# UNITED STATES PATENT AND TRADEMARK OFFICE

10/581,584

<b>Office Action Summary</b>	<b>Application No.</b> 10/581,584	<b>Applicant(s)</b> BANTLE ET AL.	
	<b>Examiner</b> MATTHEW SULLIVAN	<b>Art Unit</b> 3677

## **DETAILED ACTION**

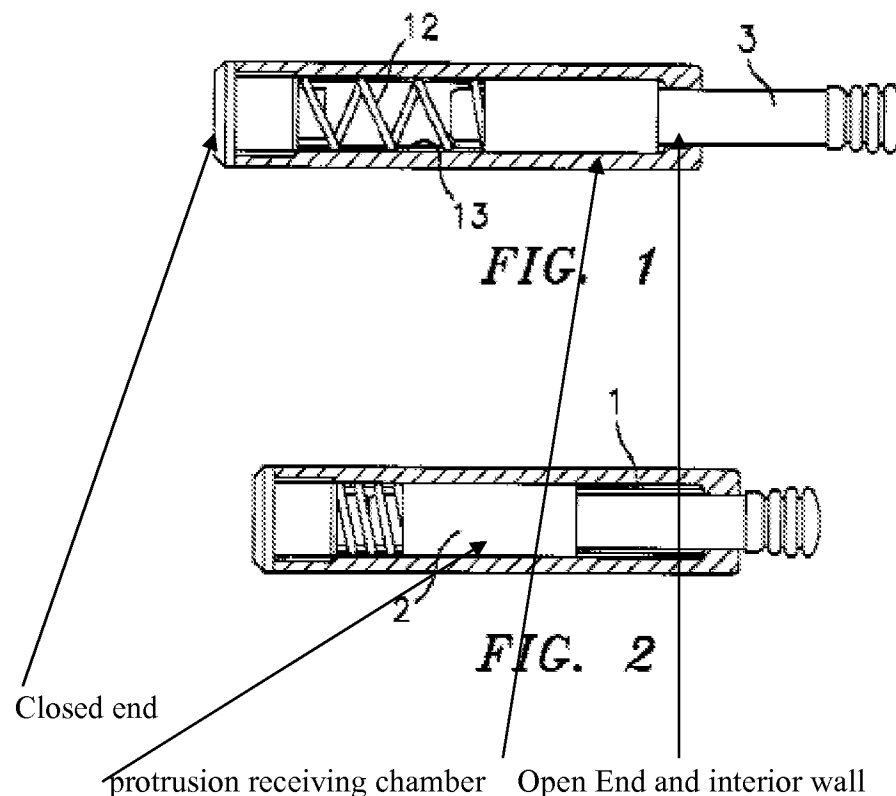
Regarding **Claims 11** and **33**, Salice '617 clearly teaches a spring (12) arranged in the receiving chamber (see below) and pushes the sliding element (2-5, collectively) at least partially out of the receiving chamber and has a spring force against which the sliding element can be pushed into the receiving chamber.

Regarding **Claims 12** and **34**, Bowden '103 clearly teaches an elastic sealing lip (18) partially spaced from the outer contour (Col 5, Lines 39-52) arranged at the end of a sliding element and extending into the receiving chamber. Bowden '103 does not teach the sealing lip substantially inclined toward the closed end of the receiving chamber, but does teach a sealing lip substantially inclined toward the open end of the receiving chamber (see figs. 2 and 6). However, the reversal of parts, barring any unforeseen result, it is generally considered obvious to one of ordinary skill in the art, *In re Gazda*.

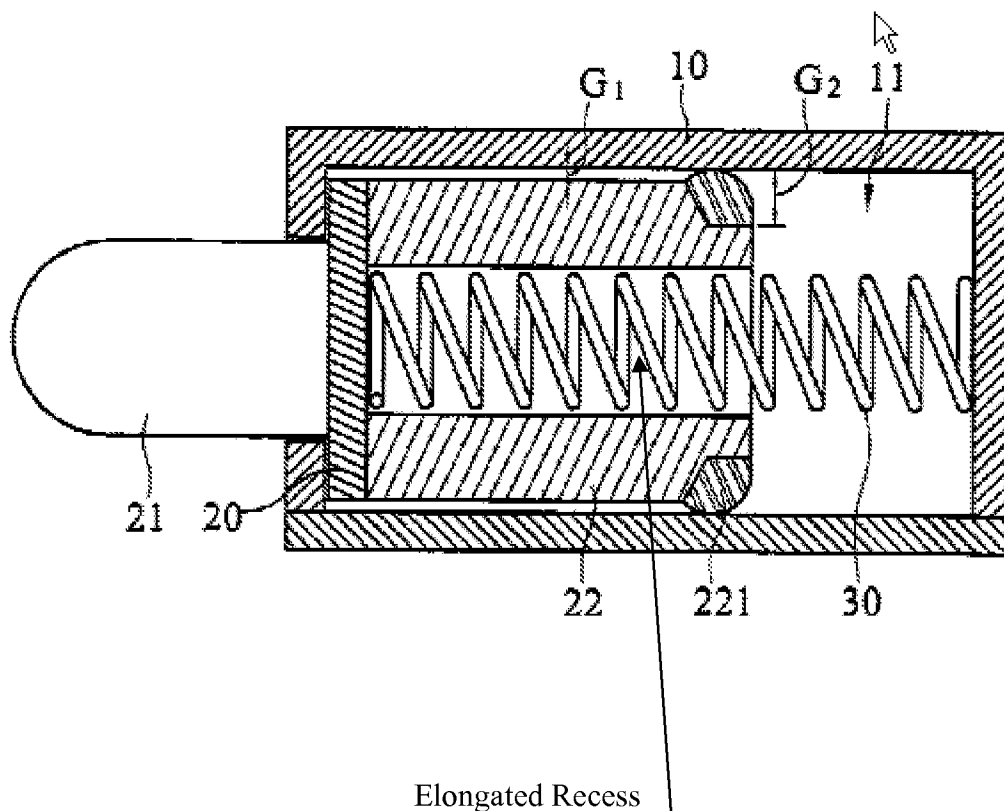
Regarding **Claim 39**, Salice '617 clearly teaches a stop element (6) with a detent head (see below) which projects at least partially over an edge area (see fig. 2) of an opening (7) at the open end of the damper body which with the sliding element pushed-in is stopped on the edge area.
